### REMARKS

Regarding the status of the present application, Claims \_ and \_ have been amended and Claims 1-5 are pending in this application. Reconsideration of this application is respectfully requested.

**Fig. 1**

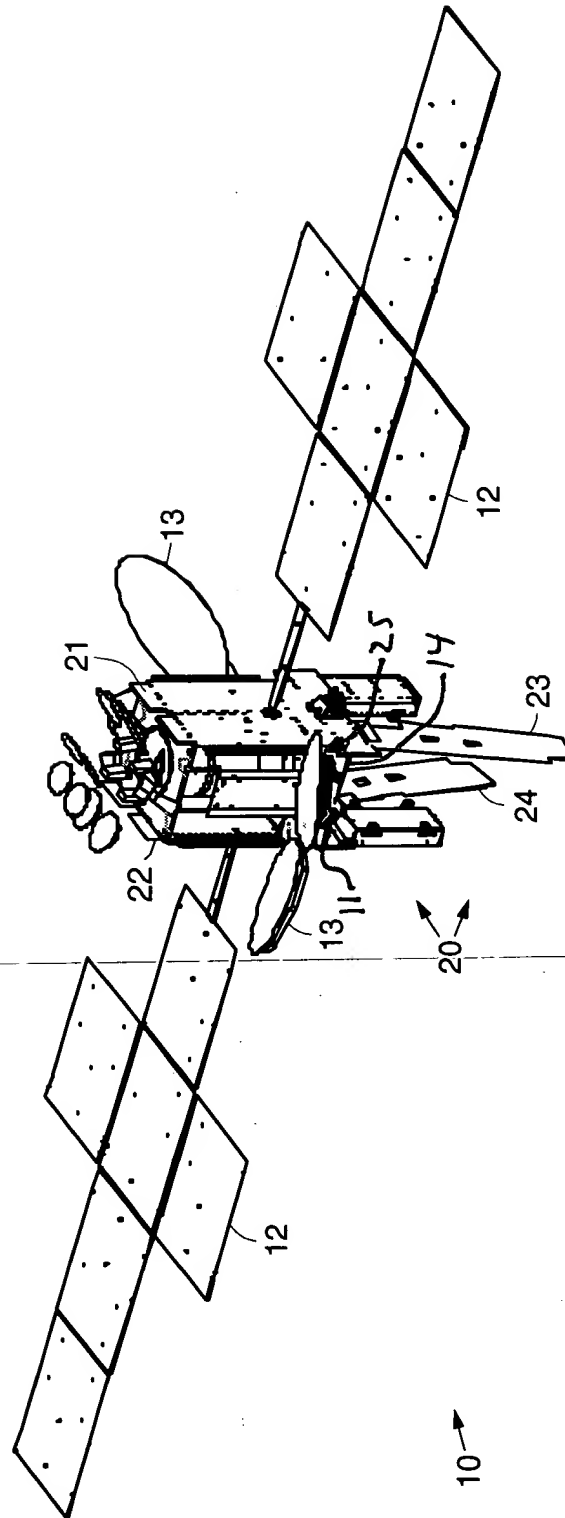
Figure 1 of the drawings was objected to because "a body 11" and "a south facing radiator 22" are recited in the specifications but are not shown on figure 1. Fig. 1 has been amended to add reference numeral "11" thereto. However, reference numeral "22" is shown in Fig. 1 at the upper left side of the spacecraft body. Figs. 2 and 3 have been amended to include reference numeral "11". Enclosed herewith are amended drawing figures containing proposed amendments marked in red ink. Also enclosed is a set of replacement reproducing masters having the amendments included therein. Entry of the amended drawings and replacement reproducing masters is respectfully requested.

Figures 1-3 were objected to because "aft deck 14" is recited in the specification but is not shown on the figures. Reference numeral "14" designating the "aft deck" has been added to Figs. 1-3 along with reference numeral "25" generally designating the "one or more coupling or loop heat pipes 25".
